## **Access Compliance Report Public Rights-of-Way** (Curb Ramps)

Intersection ID: 17298 Main Street: IDLEWILD\_RD Cross Street: NEW\_HAMPSHIRE\_DR Location: ADA ID: 77D4D67EDB09 Ramp Type: Perp Initial Pass/Fail: Fail **Overall Compliance: No Severity Score:** 12.5

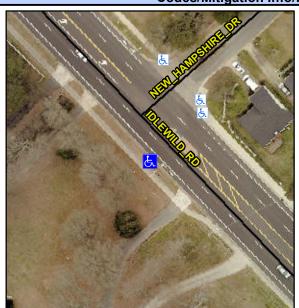
Possible Solutions: Remove & Replace Entire Ramp. Surveyor Notes: N/A PROW/ADA: Not Found, R304.2.2

Field Measurements/Component Compliance						
Comp	Compliance Description		Comp	liance Description	Data	
N/A	Ramp Length (in)	95.0	No	Ramp Slope (%)	9.2	
Yes	Ramp Width (in)	70.0	Yes	Ramp XSlope (%)	0.6	
N/A	Flare Type LT	N/A	N/A	Flare Type RT	N/A	
N/A	Flare Slope LT (%)	N/A	N/A	Flare Slope RT (%)	N/A	
N/A	Flare Traversable LT?	N/A	N/A	Flare Traversable RT?	N/A	
N/A	Landing Length (in)	N/A	N/A	DWS Provided?	N/A	
N/A	Landing Width (in)	N/A	N/A	DWS Contrast?	N/A	
N/A	Landing Slope (%)	N/A	N/A	DWS Length (in)	N/A	
N/A	Landing X Slope (%)	N/A	N/A	DWS Full Width?	N/A	
N/A	Landing Curb? (Y/N)	N/A	N/A	DWS Offset (in)	N/A	
N/A	Shared Landing?	N/A				
N/A	Gutter Ponding?	N/A	N/A	Gutter Slope (%)	N/A	
N/A	Gutter Lip Ht (in)	N/A	N/A	Gutter X Slope (%)	N/A	
N/A	Painted X Walk1?	No	N/A	Painted X Walk2?	N/A	
	X Walk 1 Direction	To NE		X Walk 2 Direction	N/A	
N/A	X Walk 1 Width (in)	N/A	N/A	X Walk 2 Width (in)	N/A	
	X Walk 1 Slope (%)	2.9		X Walk 2 Slope (%)	N/A
